2CAN070401

SUBJECT: License Amendment Request
Shutdown Cooling Automatic Closure Interlock Removal
Arkansas Nuclear One, Unit 2
Docket No. 50-368
License No. NPF-6

Analysis of Proposed Technical Specification Change

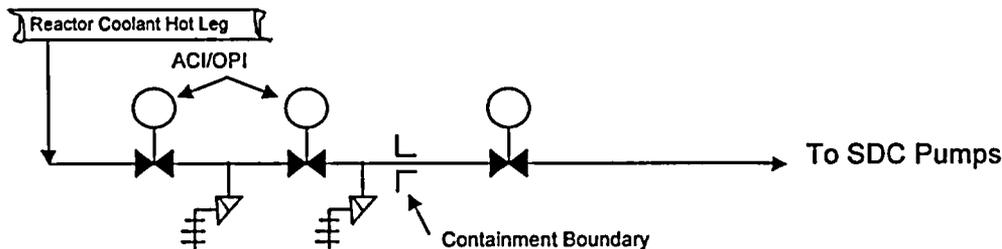
Although the reactor coolant pressure boundary ends at the second isolation valve inside containment, the penetration of the piping through the containment barrier is considered a GDC 55 (Reference 2) penetration based on the 10 CFR 50.2 definition of the reactor coolant pressure boundary (RCPB) (Reference 3). This results in a third in-series motor-operated valve located just outside of containment. The containment isolation valve is normally de-energized and locked closed. The low pressure piping downstream of the second inside isolation valve is protected from overpressure by a relief valve which is an acceptable automatic isolation device in this configuration. System configuration is illustrated simplistically below:
